Docket Item # 7 BAR CASE #2008-0234

BAR Meeting February 17, 2010

ISSUE: Alterations and Signage

LOCATION: 134 North Royal Street (Gadsby's Tavern)

Approved Viewing Window Detail

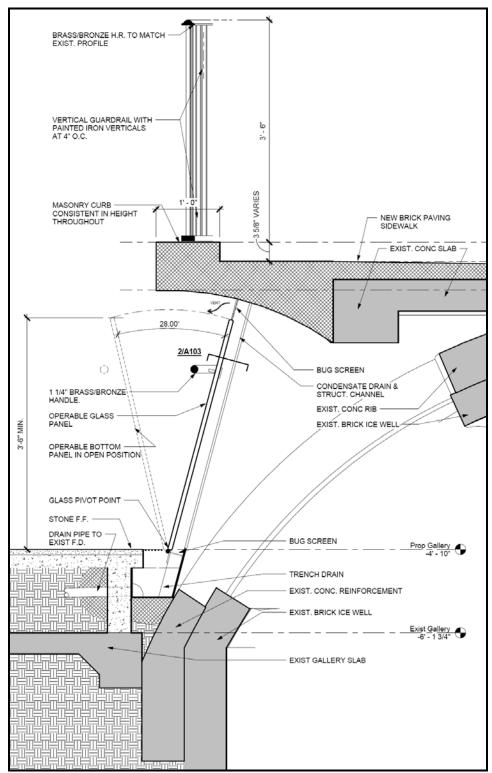
The revised design for the glass viewing panels eliminates the horizontal brass railing from the BAR's approved design, providing an unobstructed view into the well. This design refinement achieves the Board's goal of providing maximum visibility into the ice well.

Approved Stair Detail

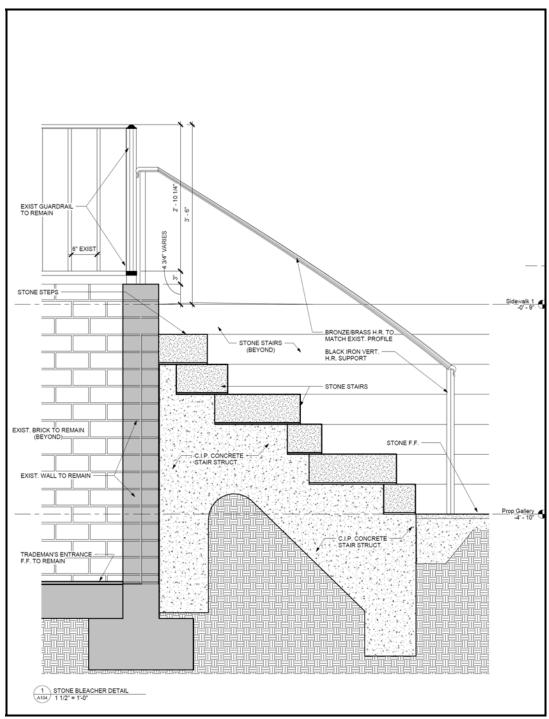
The question of the requirement for an additional staircase railing to be installed in the center of the amphitheatre steps has been reviewed by the City's Code Administration office. They have determined that the current design complies with the Uniform Statewide Building Code and the intermediate railing does not need to be added.
